**Review of a proposed
Water Management Plan,
Pickeridge Farm Quarry,
Fulmer, Bucks**

Review of Proposed Water Management Plan for Pickeridge Farm

The proposed surface drainage scheme is described in a "Groundwater Management Scheme" prepared by Frank Graham , Consulting Engineers - dated October 1995.

FIGURE 2

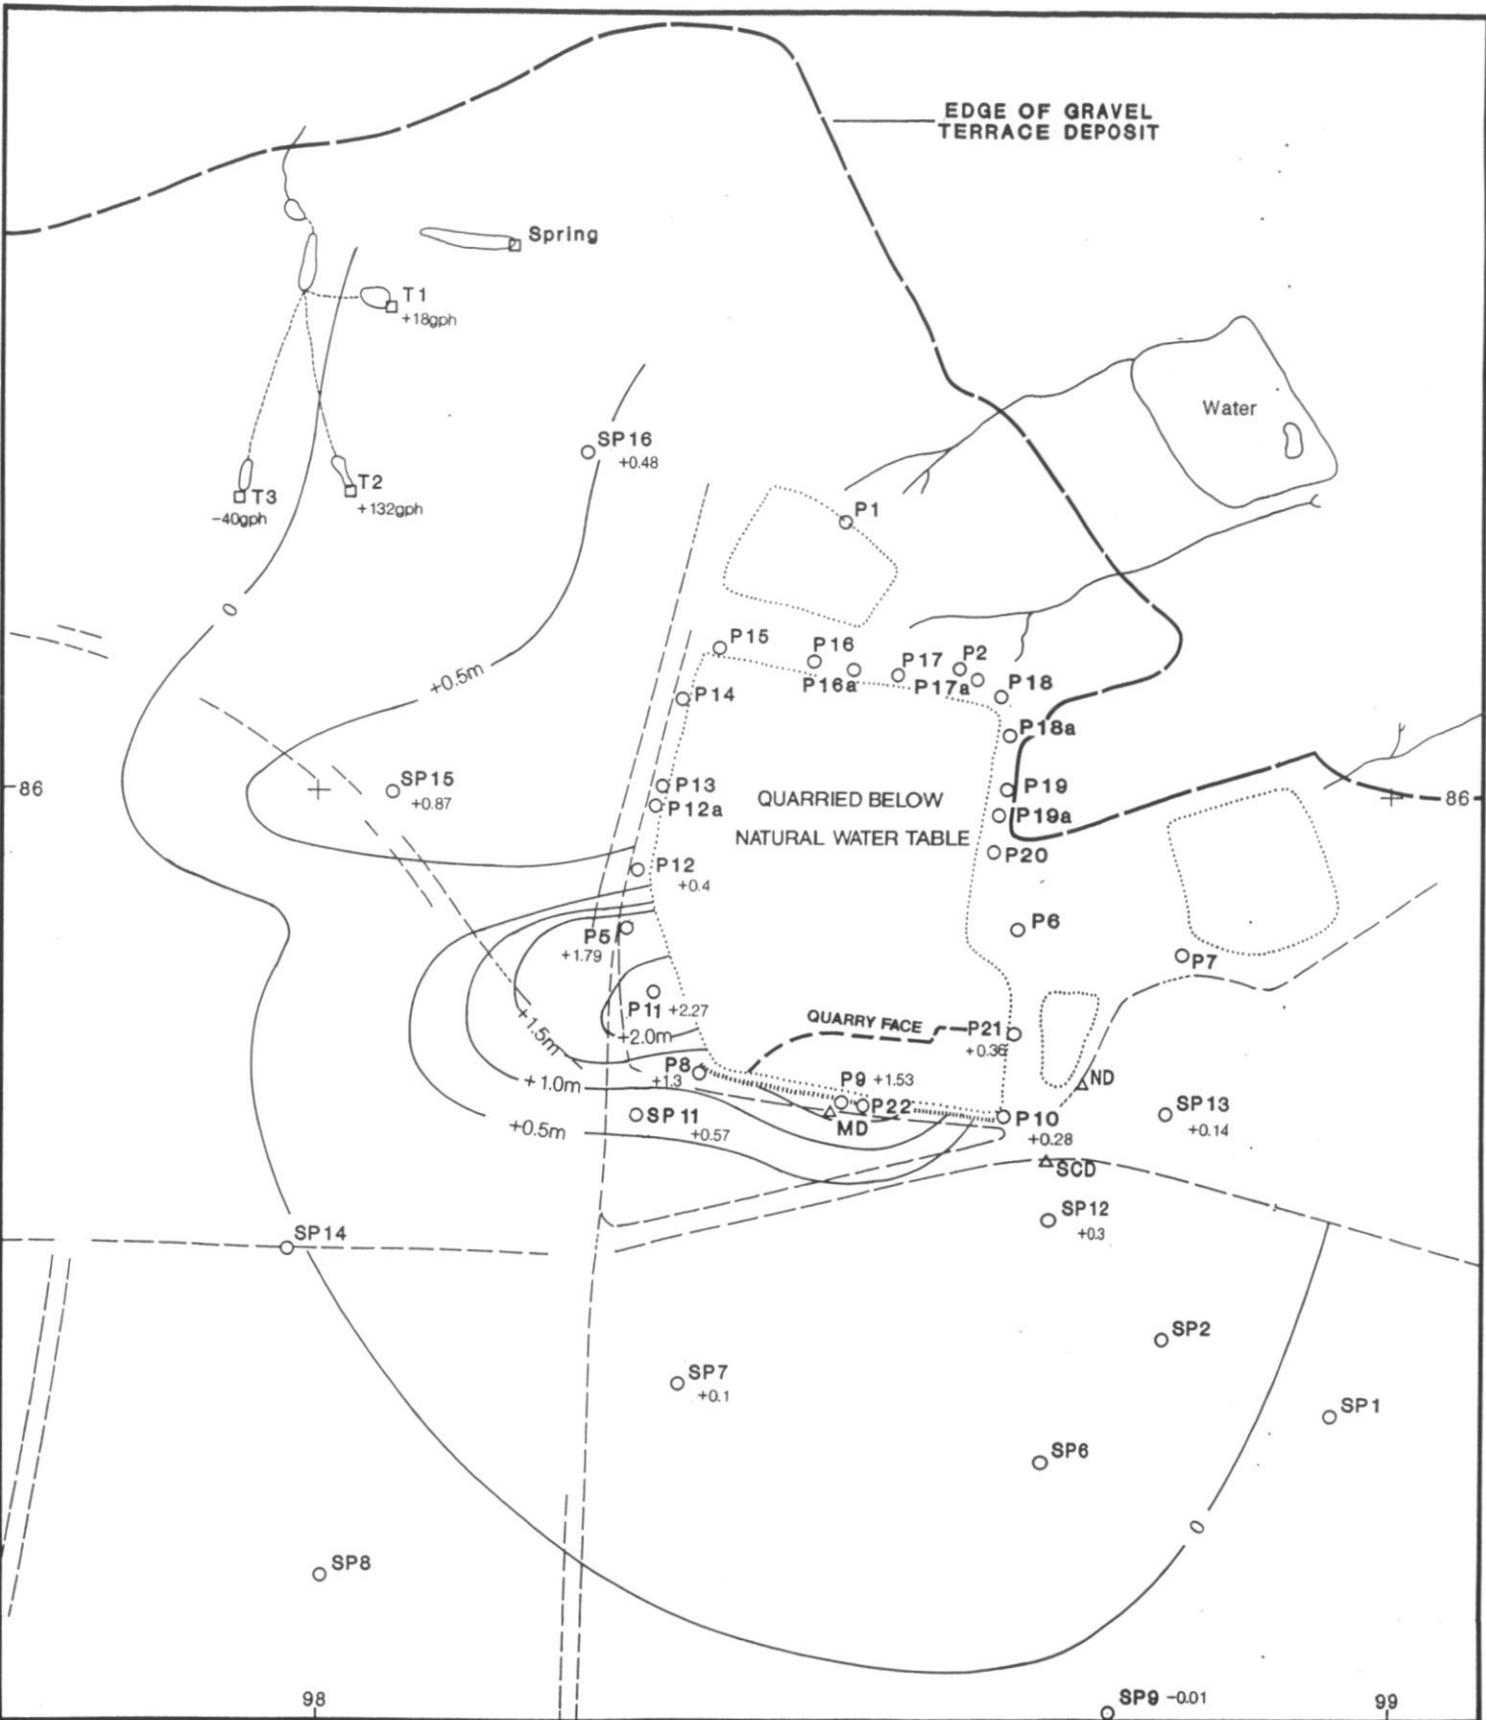
3.3.2 Increase groundwater recharge to the SSSI south east of the Quarry and particularly to the east of Cell 10.

This will be additional to recharge occurring from the trench between P8 and P10.

3.3.3 There is a risk that these channels could take away from the immediate area water

which should be recycled into the groundwater. The planned spur channels, and weir boards should be adequate to reduce this risk to acceptable levels. Any failure of the weir boards may require damming of the channels at a suitable distance from Cell 10 (say 100 metres to the east of P10).

The scale of the problem does not warrant detailed calculations of optimal heights for any weir boards. The height proposed in the Plan should be adequate, and may be adjusted if required.
